Access Compliance Report

Public Rights-of-Way

(Curb Ramps)

Intersection ID: 23868	Main Street: PINEVILLE-MATTHEWS_RD	Cross Street: REVERDY_LN	Location:	W
ADA ID: 72CBAC765C44	Ramp Type: Perp	Initial Pass/Fail: Fail	Overall Compliance: No	Severity Score: 35
Codes/Mitigation Info/Possible Solution		Field Measurements/Component Compliance

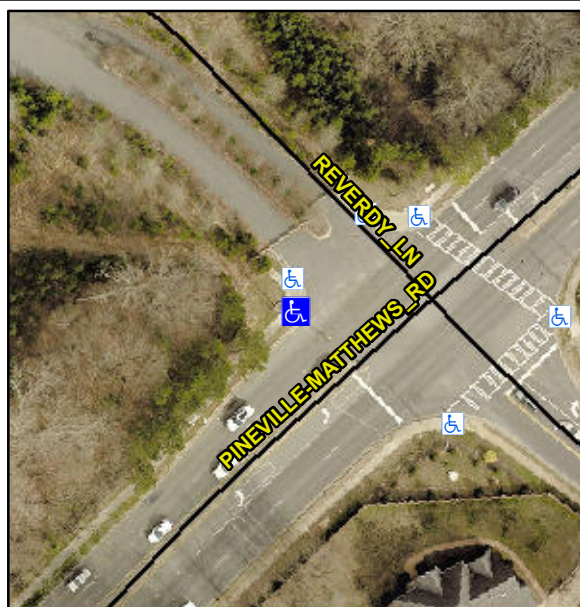
R304.5.1, R304.2.2, R304.5.3

Compliance	Description	Data	Compliance	Description	Data
N/A	Ramp Length (in)	52.0	No	Ramp Slope (%)	13.3
No	Ramp Width (in)	46.0	No	Ramp XSlope (%)	2.7
N/A	Flare Type LT	N/A	N/A	Flare Type RT	N/A
N/A	Flare Slope LT (%)	N/A	N/A	Flare Slope RT (%)	N/A
N/A	Flare Traversable LT?	N/A	N/A	Flare Traversable RT?	N/A
N/A	Landing Length (in)	N/A	N/A	DWS Provided?	N/A
N/A	Landing Width (in)	N/A	N/A	DWS Contrast?	N/A
N/A	Landing Slope (%)	N/A	N/A	DWS Length (in)	N/A
N/A	Landing X Slope (%)	N/A	N/A	DWS Full Width?	N/A
N/A	Landing Curb? (Y/N)	N/A	N/A	DWS Offset (in)	N/A
N/A	Shared Landing?	N/A			
N/A	Gutter Ponding?	N/A	N/A	Gutter Slope (%)	N/A
N/A	Gutter Lip Ht (in)	1.5	N/A	Gutter X Slope (%)	N/A
N/A	Painted X Walk1?	No	N/A	Painted X Walk2?	N/A
	X Walk 1 Direction	To SE		X Walk 2 Direction	N/A
N/A	X Walk 1 Width (in)	N/A	N/A	X Walk 2 Width (in)	N/A
	X Walk 1 Slope (%)	2.7		X Walk 2 Slope (%)	N/A
	X Walk 1 X Slope (%)	1.2		X Walk 2 X Slope (%)	N/A

Remove & Replace Entire Ramp.
